**Waterbury Filing No. 1 & 2**  
**Operations and Maintenance Manual**  
**Extended Detention Basin**  
County Job No. PUDSP-21-005

## **GRADING AND EROSION CONTROL PLAN CHECKLIST PUDSP-21-005**

**Site: Waterbury Filings 1& 2**

GRADING AND EROSION CONTROL PLAN  
INTERIM EROSION CONTROL PLAN 1

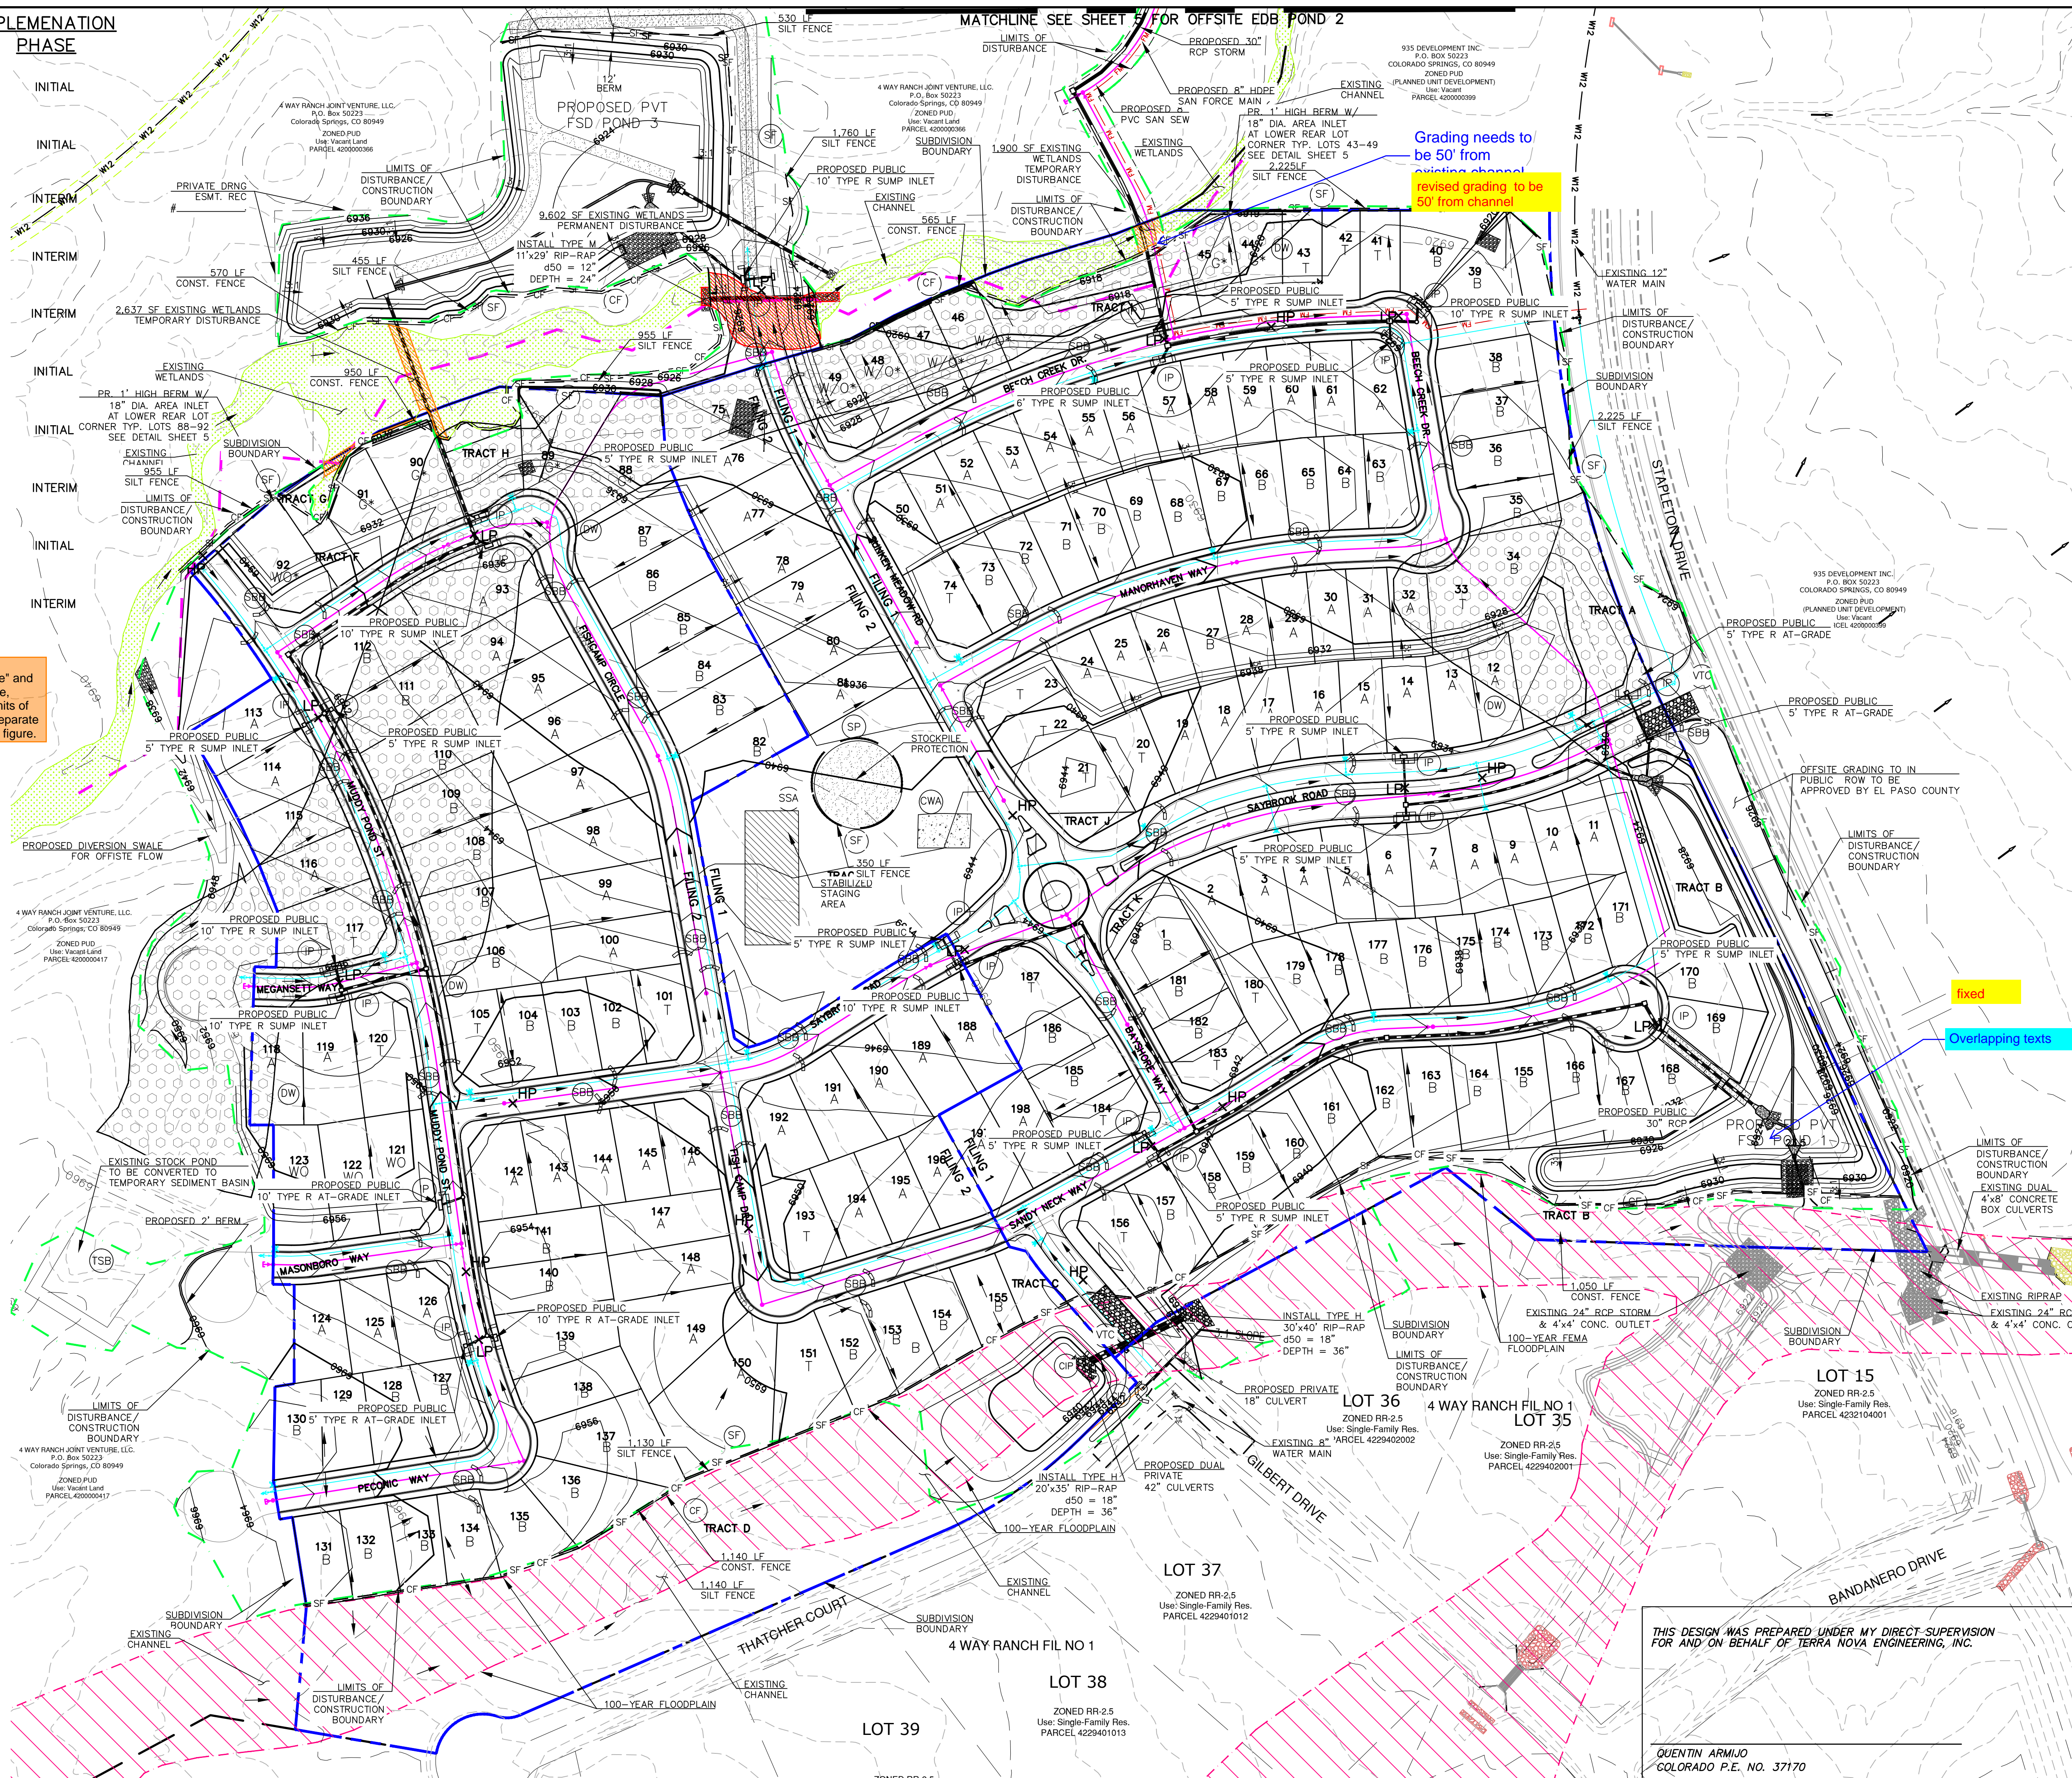
Unresolved from Review #1 and #2:  
Item H and M. If "limits of disturbance" and  
"construction boundary" are the same,  
change to "construction boundary/limits of  
disturbance" or otherwise show as separate  
linetypes for each on the legend and figure.

ADDED

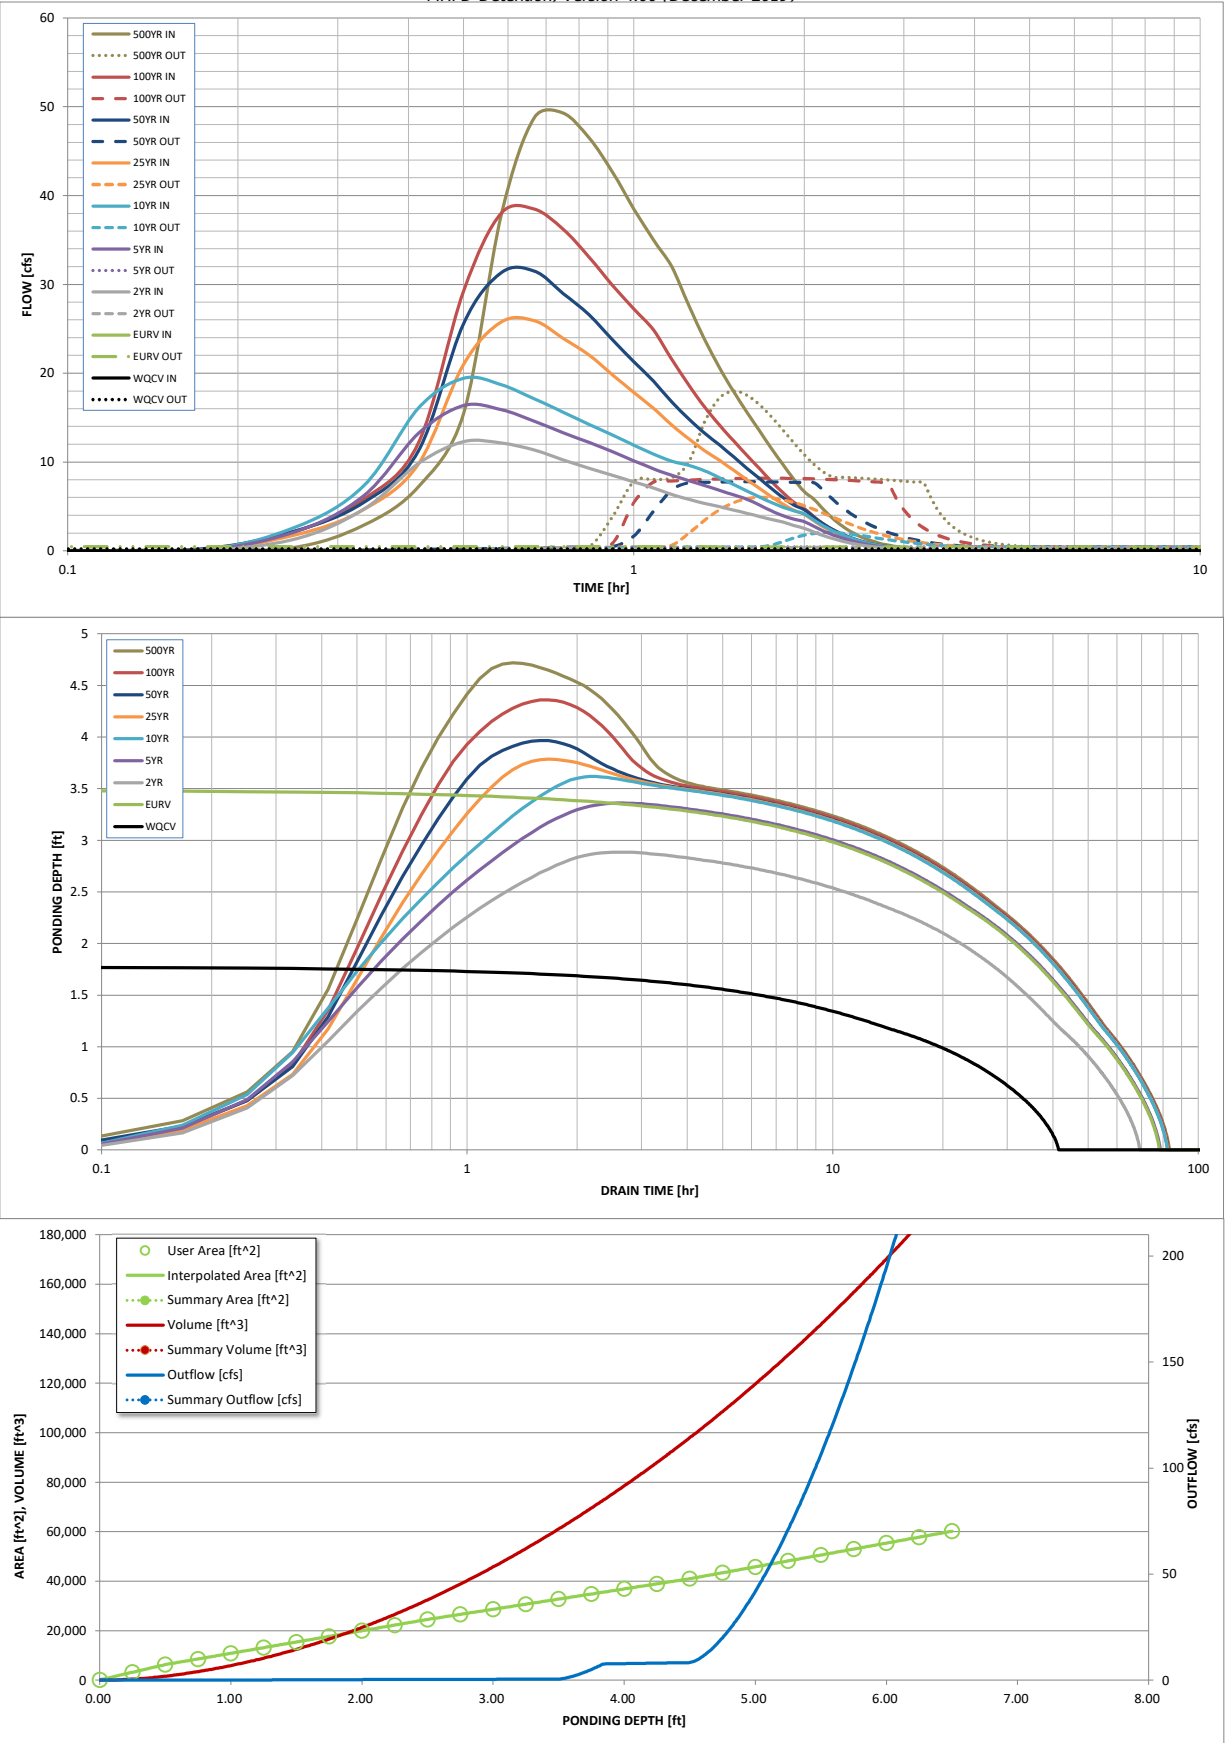
59 calculated - check sheet  
input to approximate that  
minus IRF % **REVISED**

Should be <1  
**REVISED**

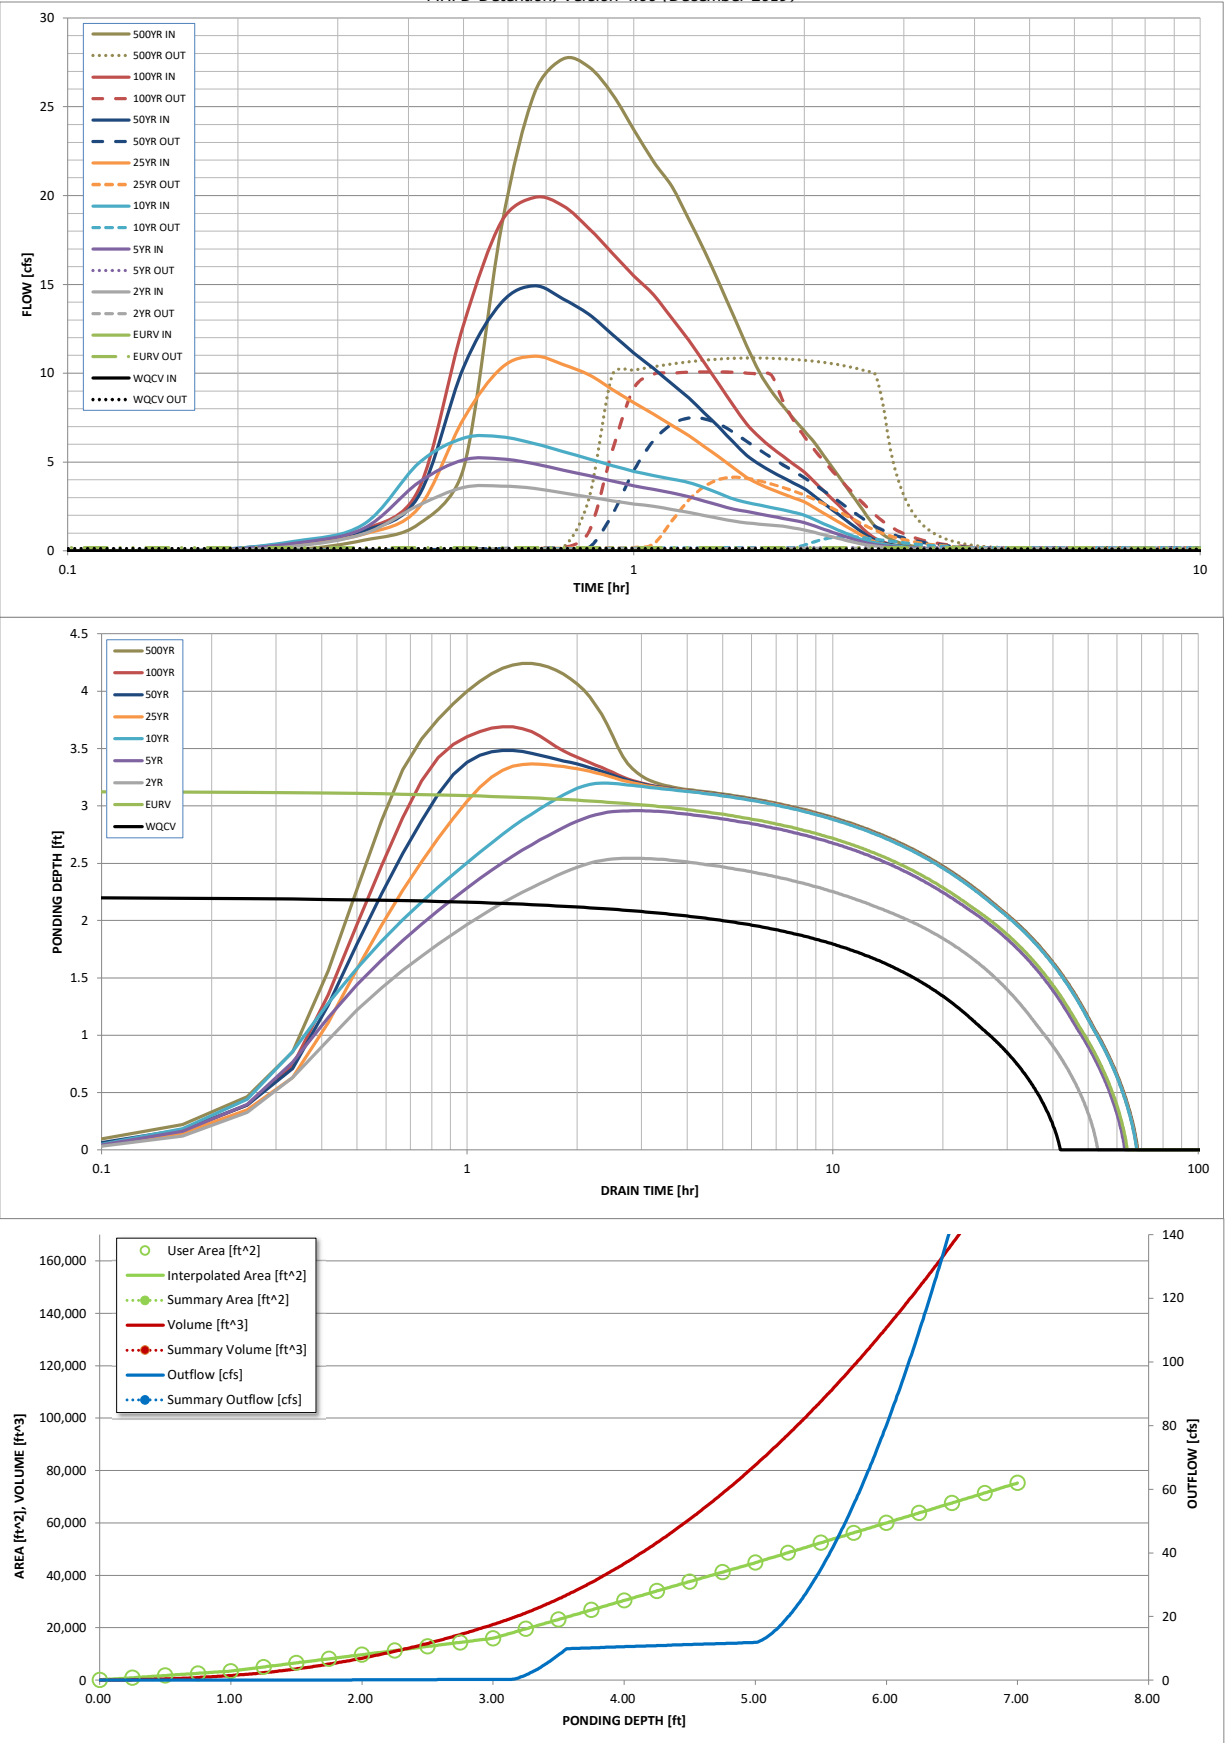
(same comment as Pond 1  
- should be closer to 29 cfs  
minus IRF %)

REVISED

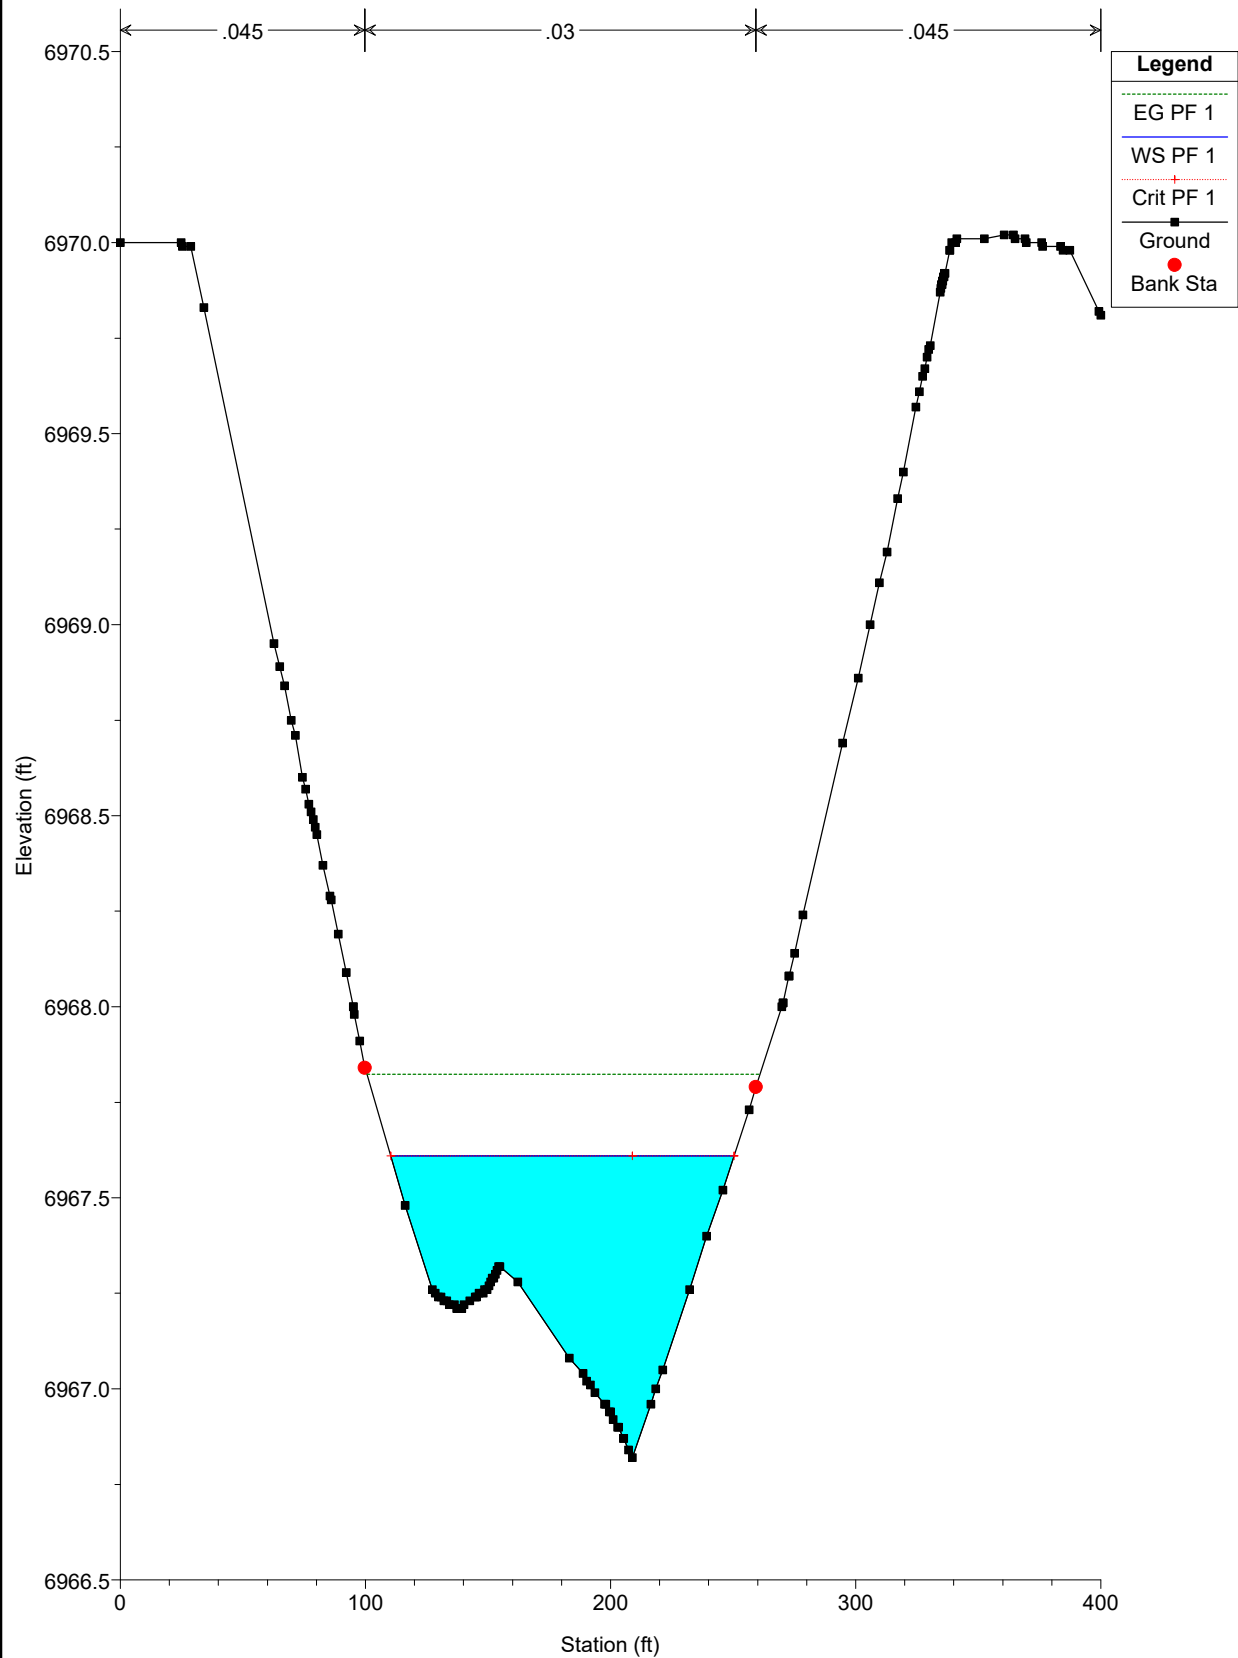
Stabilization /  
modification needs to  
be provided where  
flows are supercritical

ALL FROUDE #S ARE LESS THAN 1  
EXCEPT AT DROP STRUCTURE STA  
14+20 AND STA 1+00 WHERE HECRAS  
ALWAYS HAS CRITICAL FLOW AT LAST  
STATION DO TO NO DOWNSTREAM  
SECTION TO RUN THE CALCS
